**Re: LFPCN41457 TPSMDxx DO214-AB Automotive TVS capacity expansion and BCP**

# PCN Report

**Prepared By** :Kimi xiong, Product Engineer  
**Date** : Aug 9th, 2022  
**Device** : DO-214AB(SMC) automotive TVS  
**Revision** : A

Automotive TVS TPSMD Product Series

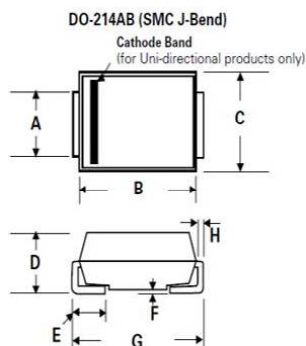
Change Description		Before	After	Benefits
BE	Manufacturing Line	Existing line	Existing line & New line	Capacity expansion
	Clip vendor	Clip vendor: G-Shank	Clip vendor: 1. G-Shank 1. JIH Long	2 <sup>nd</sup> source & BCP

No	Package outline dimension(mm)			
	POD Spec		Actual	
	Min	Max	Before	After
A	2.90	3.20	3.10	3.11
B	6.60	7.11	6.73	6.74
C	5.59	6.22	5.97	5.99
D	2.06	2.62	2.45	2.22
E	0.76	1.52	1.15	1.11
G	7.75	8.13	7.97	7.94

About TPSMD (released already) is SMC existing line product, PKG size is a little different compare with SMC new-line and all of them within tolerance base on POD spec after change
